2016+ Mazda MX5 (ND) Differential Case/Cover Modification Reference for OS Giken Super Lock LSD Installation

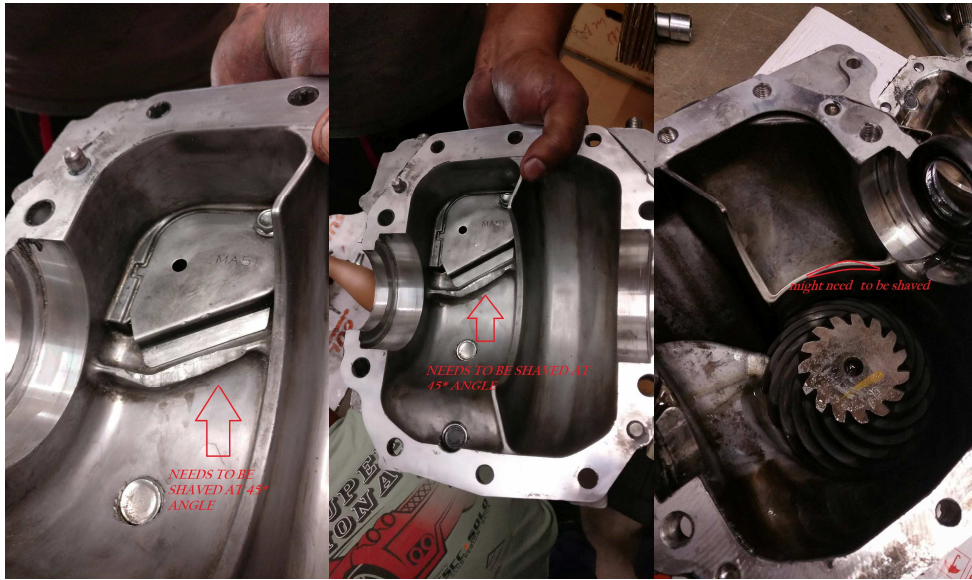
1. The 2016+ Mazda MX5 may require shaving the LSD case for proper clearance to the LSD cover. The LSD has very tight clearances to that area and requires close attention to detail during installation. Clearances can vary from carrier to carrier and may require this modification. Please contact your local gear shop professional for installation.
2. The 2016+ Mazda MX5 **requires** shaving the LSD cover for proper clearance to the LSD itself.
